6572A-08

S E R V I C E N O T E

**6572A - DC POWER SUPPLY, 0-20 V, 0-100 A, 2000 W
MANUALLY CONTROLLED**

The four filter capacitors circuit reference (C416-C419) on the A4 AC input board starts leaking electrolyte

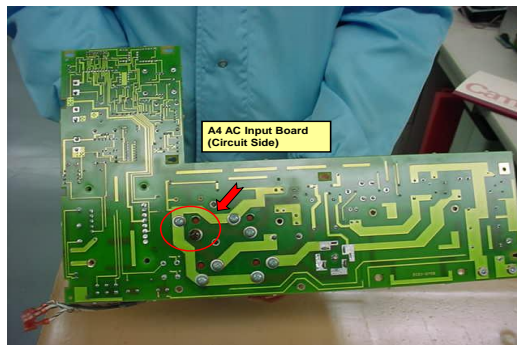
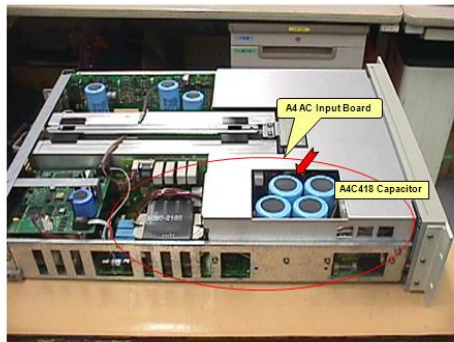
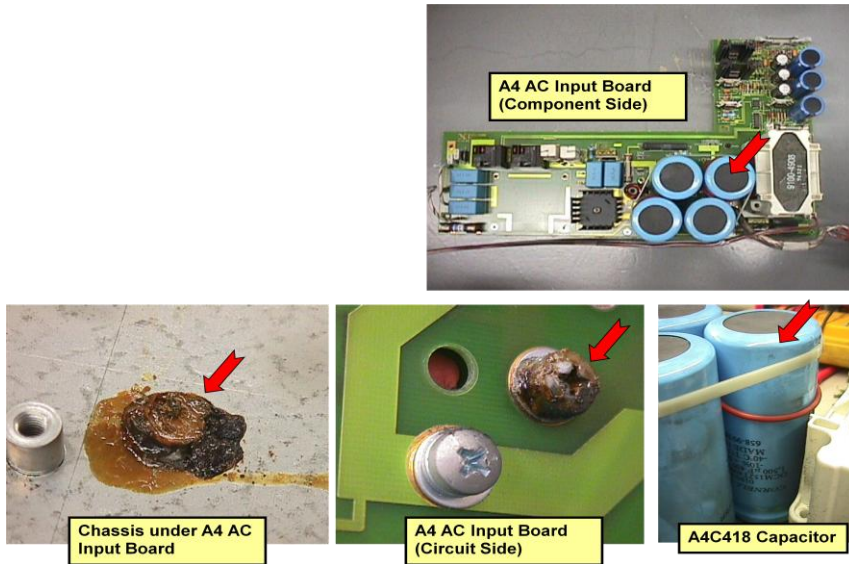
The four filter capacitors circuit reference (C416-C419) on the A4 AC input board starts leaking electrolyte - not through the pressure valve in the bottom as one would expect but through one of the terminal screw bushings.”

The screw P/N 2680-0217 length currently being used was not considered and the length was overlooked. The screw length is 0.375 inches long. We have found that the screw can be 0.055 inches too long and may bottom out causing the tapped hole in the header of the capacitor to become cracked or become broken.

When this happens the electrolyte will slowly leak out over time, and cause the defect described. This situation is even worse due to the capacitor is mounted with the header face down. If the capacitor was mounted header face up a cracked or broken header would not have caused this problem, the electrolyte could not leak out.

Replacement instruction for C416-419

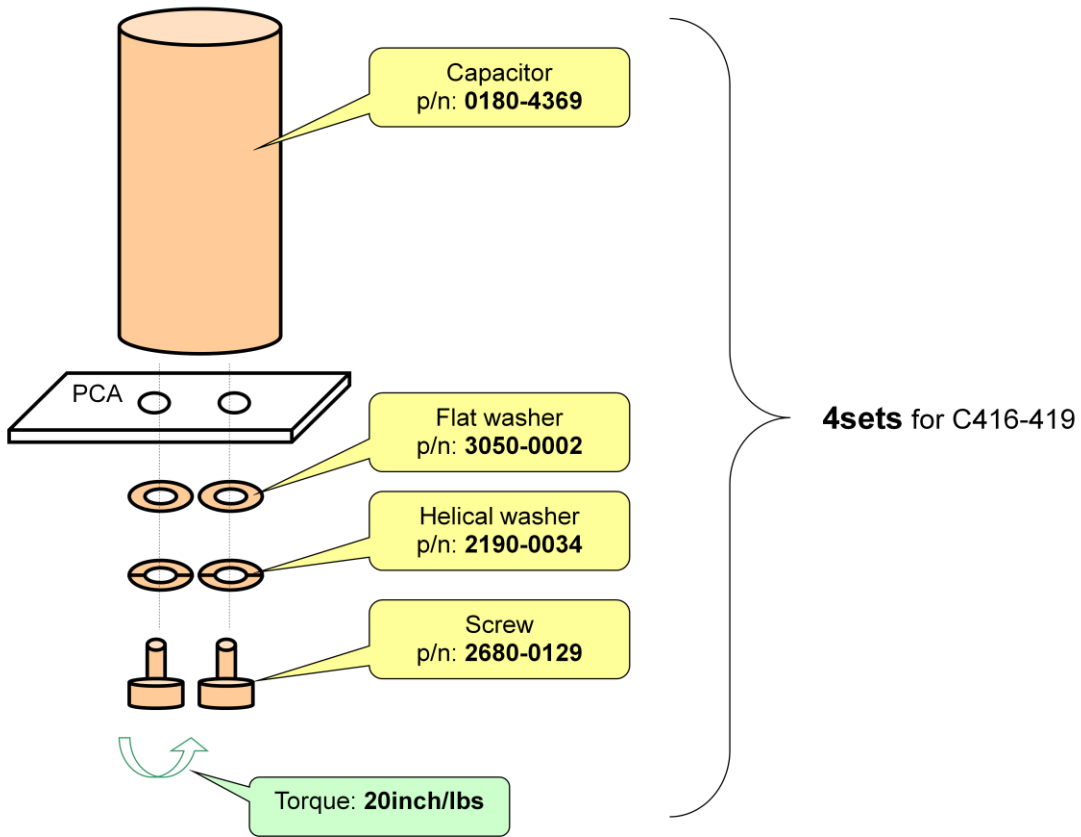
1. All affected models and tested assemblies WIP (Work In Process), FGI (Finished Goods Inventory) at SPO (Support Parts Organization) & AMC (Asian Manufacturing Center) has been inspected for capacitors with damaged headers due to the incorrect screw
2. When this repair is being done all of the hardware described above should be replaced (It is NOT recommended that any of the hardware be reused)
3. The following figures can be used when doing the repair.
4. Inspect the assembly as described below.
5. The last figure will aid in the reassembly of the hardware and the capacitors.
